## QUALITY ASSURANCE -- NON-CONFORMANCE REPORT

**Report No:** NCR-000548

**Reference Description:** Improper Weld Preheat, Segment 9BW

**Job Name:** SAS Superstructure

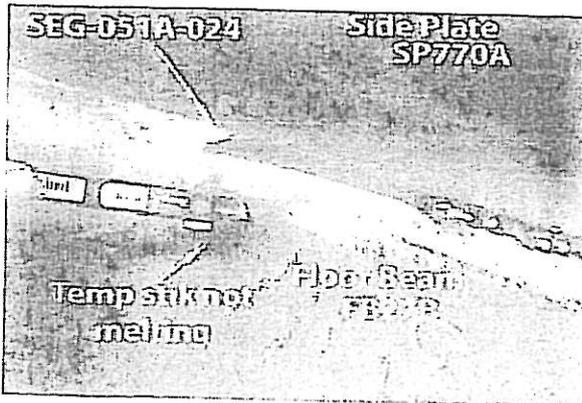
During a random visual inspection of Shielded Metal Arc Welding (SMAW 4G) on Segment 9BW, the Caltrans Quality Assurance (QA) Inspector observed ZPMC personnel in-process of welding a complete joint penetration (CJP) weld without achieving the required preheat temperature of 60 degree C as per approved welding procedure specification (WPS).

- 1) The WPS was identified as: WPS-B-C-2214-Tc-U4b-FCM-1
- 2) The weld joint was identified as: SEG-051A-024
- 3) Side Panel (SP) plate is identified as: SP770A
- 4) Floor Beam (FB) plate is identified as: FB27B
- 5) The welder was identified as: Welder ID # 066413
- 6) This material being welded is A709 Grade 345 Seismic Performance Critical Material (SPCM).
- 7) The weld is located between the SP770A to FB27B Cross Beam (CB) side at PP76.
